LINE OF BUSINESS PORTABLE AUDIO

SERVICE NEWSLETTER

LINE OF BUSINESS AUDIO SYSTEMS

SERVICE NEWSLETTER

Portion of the Front board (copper side view)

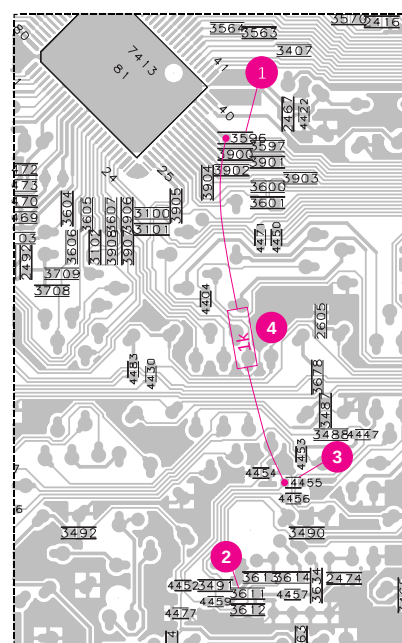
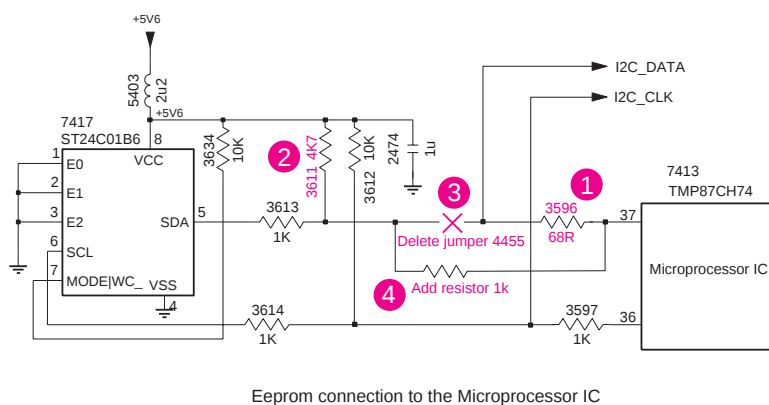
The set behaves strangely after switching it on via Standby button or mains supply re-connection. Strange behaviour includes:

: The problem is caused by corrupted data being written into the EEPROM IC 7417 via the I2C_DATA line. The data corruption can be verified and cleared by performing an “EEPROM Format Test” in the Service Test Program.

The problem can be solved by the following hardware modification on the front board:

1. Ensure (change if necessary) that resistor 3596 is 68Ω (4822 117 12521)
2. Change resistor 3611 to 4.7kΩ (4822 051 20472)
3. Remove SMD jumper 4455
4. Add resistor 1kΩ (4822 050 11002) with insulated leads between pin 37 of microprocessor IC 7413 and junction of resistors 3611 and 3613 (left solder pad of jumper 4455)
5. Clear the corrupted data in the EEPROM as follows:
 - a) Enter the Service Test Program by holding the **PLAY ►** and **AUX** button depressed while switching on the mains supply
 - b) Perform an “EEPROM Format Test” by pressing the **SEARCH ◀◀** button to reset the EEPROM to default data
 - c) Exit the Service Test Program by disconnecting the mains supply

Portion of the Front board (copper side view)

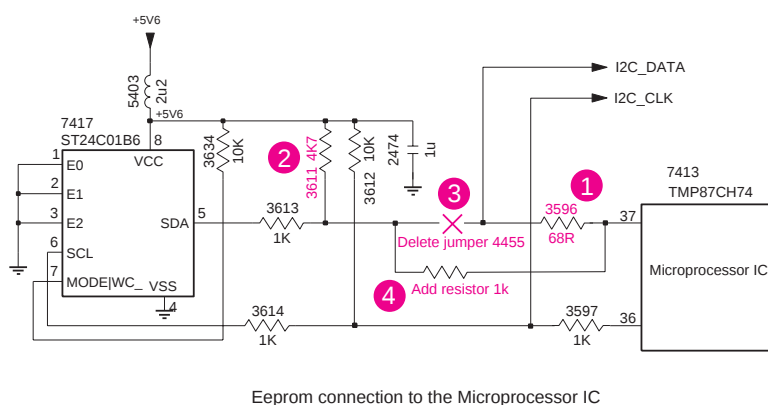
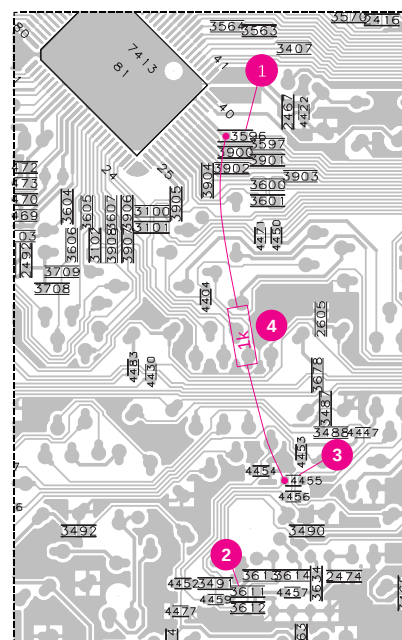
The set behaves strangely after switching it on via Standby button or mains supply re-connection. Strange behaviour includes:

CURE : The problem is caused by corrupted data being written into the EEPROM IC 7417 via the I2C_DATA line. The data corruption can be verified and cleared by performing an “EEPROM Format Test” in the Service Test Program.

The problem can be solved by the following hardware modification on the front board:

1. Ensure (change if necessary) that resistor 3596 is 68Ω (4822 117 12521)
2. Change resistor 3611 to 4.7kΩ (4822 051 20472)
3. Remove SMD jumper 4455
4. Add resistor 1kΩ (4822 050 11002) with insulated leads between pin 37 of microprocessor IC 7413 and junction of resistors 3611 and 3613 (left solder pad of jumper 4455)

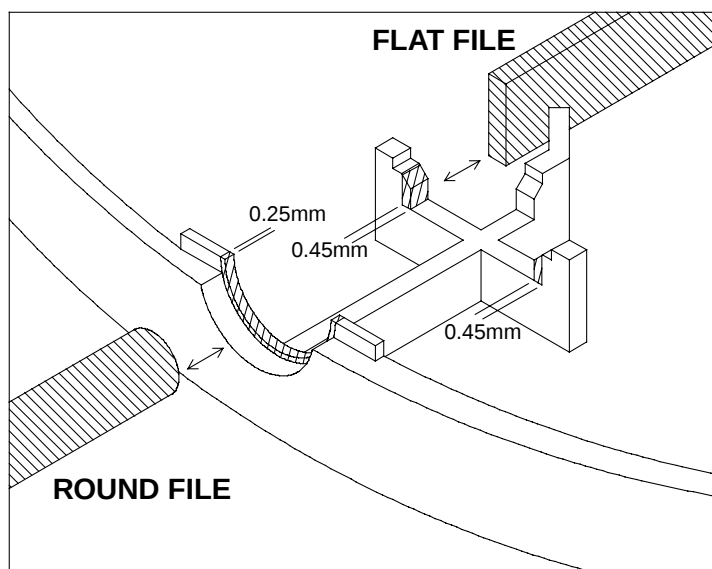
INFORMATION : In course of production, the PCB Assembly was changed to PB2 (for details please refer to Service Manual 4822 725 26021).
In the PB2 assembly a smaller headphone jack was used and thus the hole for h/p jack on the cabinet was also made smaller.
The cabinet (4822 449 80201) of the sets produced in earlier stage is no longer available and the new cabinet (4822 449 80266) with smaller jack hole will be delivered as substitute.

As a service solution, for repairing sets with bigger headphone jack, we suggest to enlarge the hole by use of files (see drawing below).

fig.1 – location of flex-foils

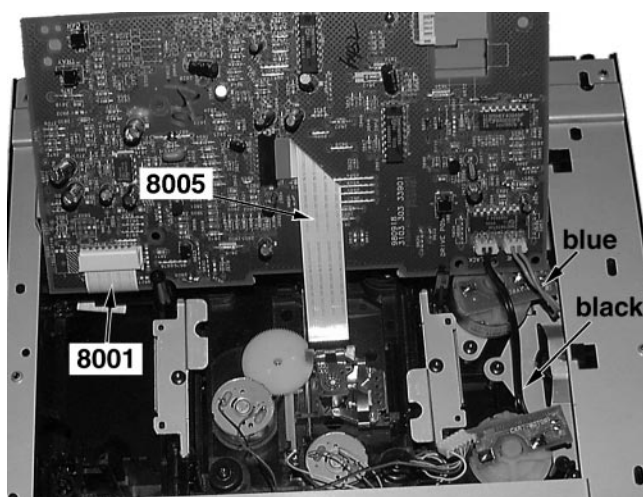
INFORMATION : Correction to the Service Manual, Partslist
The following flex-foils and flex-foil-connector were missing and have been added to the partlist of the 3CDC-99 Module (chapter 10).

pos.	code number	article description
1805	2422 025 09768	Flex-Foil-Connector 19P
8001	4822 320 12232	Flex-Foil 15P 480mm
8001	4822 320 12658	Flex-Foil 19P 480mm
8001	4822 320 12659	Flex-Foil 23P 480mm
8001	4822 320 12729	Flex-Foil 23P 400mm
8005	3103 308 91820	Flex-Foil 15P 95mm

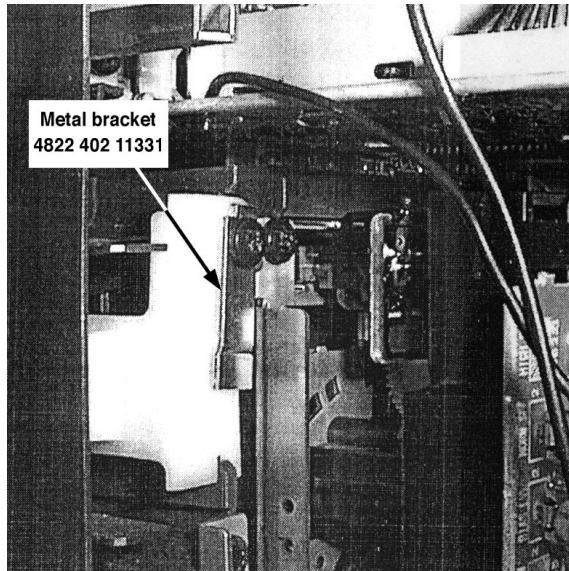
CURE : In addition to Newsletter issue AS98.09.03, the improved brackets (left & right) can be recognized by the modification shown below:

- i) adding a metal bracket (4822 402 11331) to press onto the back of the bracket left or right as shown below, or

- ii) replacing the old bracket by the modified one.

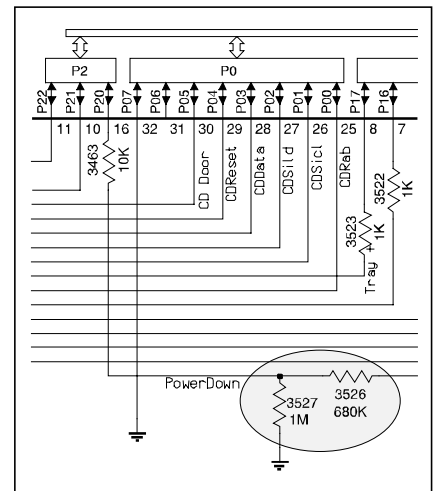
Sound is muted or distorted at start-up when playing a CD containing only two tracks.

CURE : The problem can be solved by adding a resistor of 100k Ω (4822 116 52234) across C445 on the CD board.

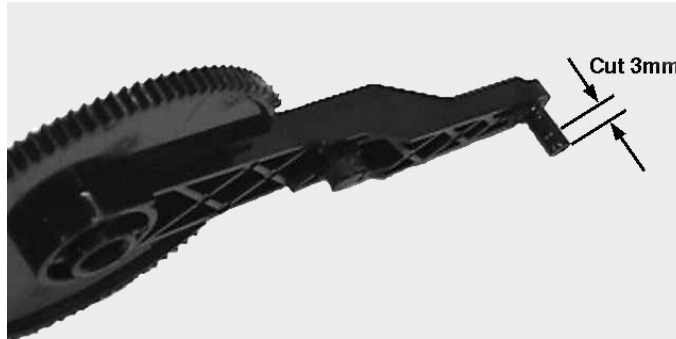
From production wk9835 onwards, the Tray and Crank have been modified. The groove on the tray is now deeper and likewise the pin on the Crank is 3mm longer.

Due to this change the new Crank does not fit into the old Tray anymore. But it is still possible to use the old Crank on the new Tray.

Because of limited stock of old Cranks, new Cranks have to be reworked for sets with an old Tray. This is done by cutting the pin by 3mm with a sharp NT-cutter (give it a clean cut & do not deform its circular cross-section) as shown below.

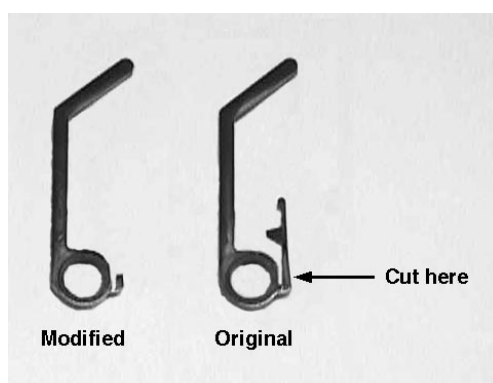
When CD tray was activated to open, the tray would move out and immediately go in again or stop at half way.
When the CD tray is in motion the inside arm of the switch bracket (pos 123) hits the micro switch earlier than the main lever.

CURE : The problem can be solved by cutting a section of the inside arm of the switch bracket as indicated below:
